Corrigendum to “Interdependencies between physical, design and operational parameters for direct use geothermal heat in faulted hydrothermal reservoirs” [Geothermics, 86 (2020) 101806](S0375650519303785)(10.1016/j.geothermics.2020.101806)

Corrigendum to “Interdependencies between physical, design and operational parameters for direct use geothermal heat in faulted hydrothermal reservoirs” [Geothermics, 86 (2020) 101806]

Figure 9 Published.

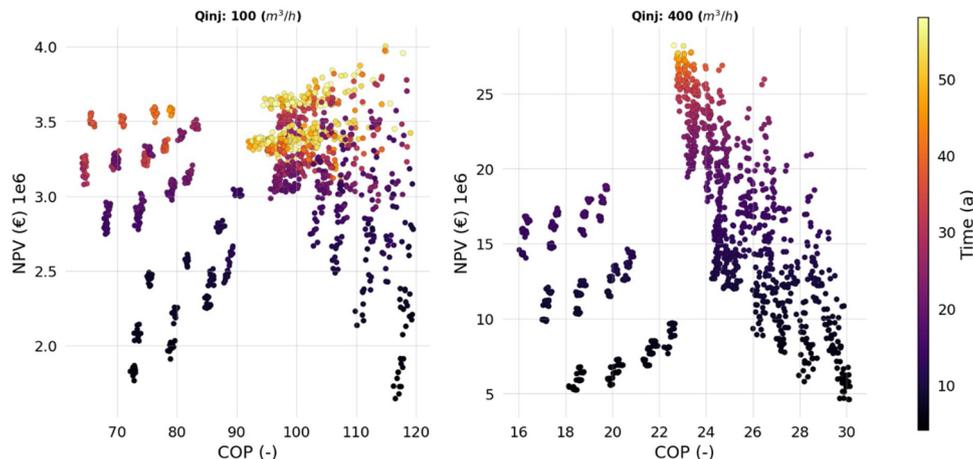
As the code was actively developed during the time of publication, the published data suffer from an error with regards to the discount factor applied during the NPV calculation. The published data NPV has been calculated for periods of 100 days, while the discount rate applied was the quoted Annual Discount Rate (ADR) value of the manuscript, namely 7%. When the NPV is calculated at intervals shorter periods than a year, the discount rate needs to be adjusted accordingly. This adjusted Periodic Discount Rate (PDR) should be calculated according to the following equation:

This was not done for the published data, due to different versions of the code being used. As a result, the time value of money was discounted much more than it should be (7% each 100 days when it should be 1.8697% per 100 days), leading to lower NPV values. This affects section 3.3 “Lifetime and NPV” of the published article (Figures 9, 10 and 11). We have re-performed the processing after having addressed this issue and plotted the corrected data in the updated figures below. While the qualitative conclusions that were drawn from the published figures are not significantly different from the corrected ones, the quantitative NPV values of the corrected figures differ substantially.

$$PDR = (1 + ADR)^{period/year} - 1$$

For our data this means that the PDR should be 0.018697 or

1.8697% for each period of 100 days for which the NPV is calculated.
